Site Plan 8-98001

REVISED MEMORANDUM

DATE: January 16, 1998
TO: Montgomery County Planning Board
FROM: Wynn E. Witthans, ASLA, AICP *WW*
Development Review
Planning Department Staff
(301) 495-4584
VIA: Charles Loehr, Chief, *CL*
Development Review
REVIEW TYPE: Site Plan Review
APPLYING FOR: 768 units: 75 SFD, 295 Townhouses, 398 multifamily inclusive of 96 MPDU's

PROJECT NAME: Clarksburg Town Center - Phase I
CASE #: 8-98001

B. Conformance to the Master Plan for Historic Places

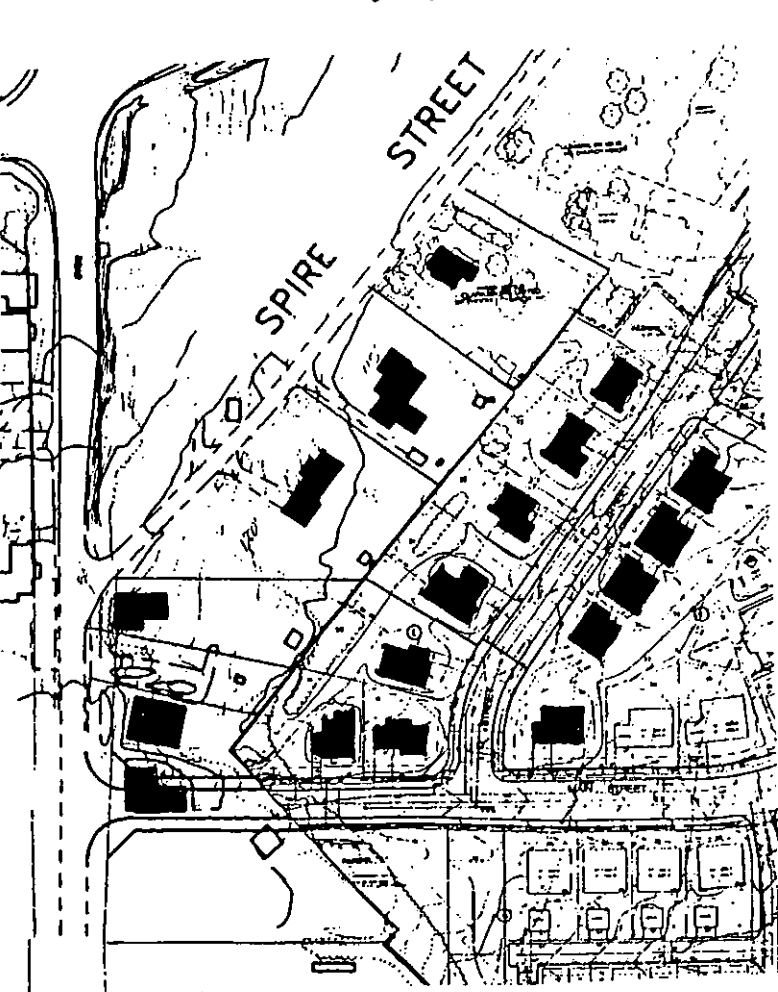
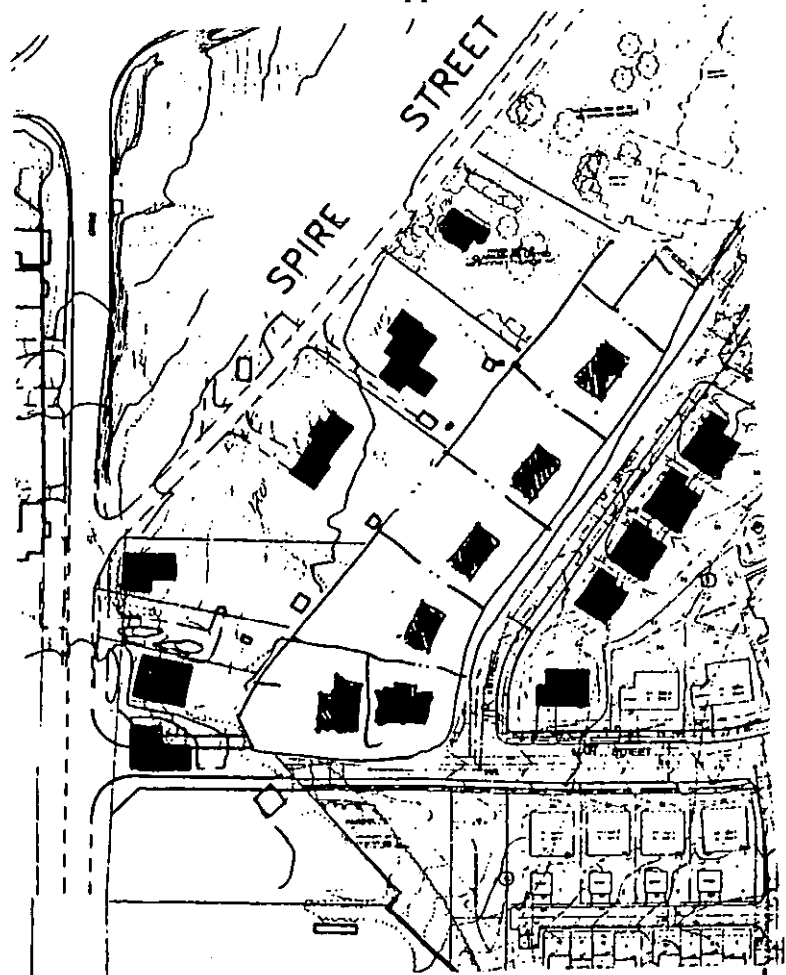
The Clarksburg Historic District is on the Master Plan for Historic Preservation and adjoins the proposed site plan along its western boundary,

The removal of a proposed house is to create compatibility between the two projects utilizing similar scaled and dimensioned buildings and surrounding open spaces. The existing condition on Spire Street has three homes that have lot widths at their building face of 130 ft, 115 ft and 180 ft. The lots along MD 355, whose rear yards adjoin the common boundary, have 40 and 60 foot widths at the front building line. The proposed six lots have 2 lots with 68 foot widths at the front building line, one lot at 65 feet, one lot at 990 feet, one lot at 88 feet and one lot at 120 feet. The average frontage for all six lots is 83 feet. The approved Project Plan condition reads: *"...the size of lots and setbacks of the proposed development must match, approximately, the development standards in the R-200 Zone for building setbacks and width of lots along the southeastern boundary of the site..."* **The required lot width along the front building setback line is 100 feet.** The dimensions of the proposed lot widths and the sketch below show the lack of conformance with the desire of the HPC and the Planning Board's earlier decisions. The staff proposal clearly shows that the 100 foot lot widths work to create an appropriate transition between the existing Historic District and the proposed units. See memo of January 15, 1998 from the Historic Preservation Commission in the Appendix.

32. ~~One lot should be deleted from the~~ The lot lines shall be adjusted so to include Outlot "A" to single family home area directly adjacent to the Historic District, to fulfill the Project Plan condition to approximate R-200 zone lot width standards.
